*****END OF ADDENDUM #2*****

PROJECT
SERVICE CENTRE REPLACEMENT
MEADOW LAKE PROVINCIAL PARK
SANDY BEACH CAMPGROUND

DRAWING
WALL TILE CORNER TRIM

① PLAN DETAIL- TYP.
WALL TILE CORNER TRIM

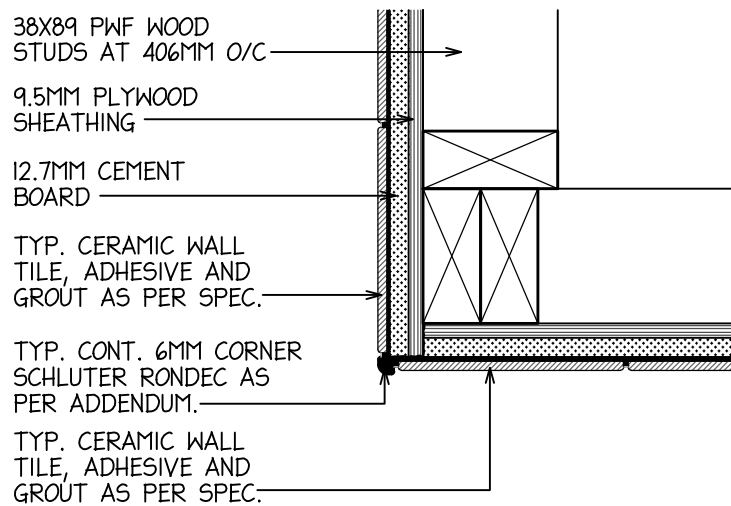
- 2.1 Please refer to Specification Section 09310, Item 3.1.7 and delete reference to “*Make external angles rounded and bullnosed*”.
- 2.2 At exterior corner where wall tile is installed, provide continuous vertical bullnosed type profile “RONDEC” schluter trim, with 6mm radius, integrated trapezoid – perforated anchoring leg and integrated grout joint spacer. Finish to be EB Brushed Stainless Steel Type 304 = V2A. Refer to drawing AR.1 (copy attached) for further clarification.
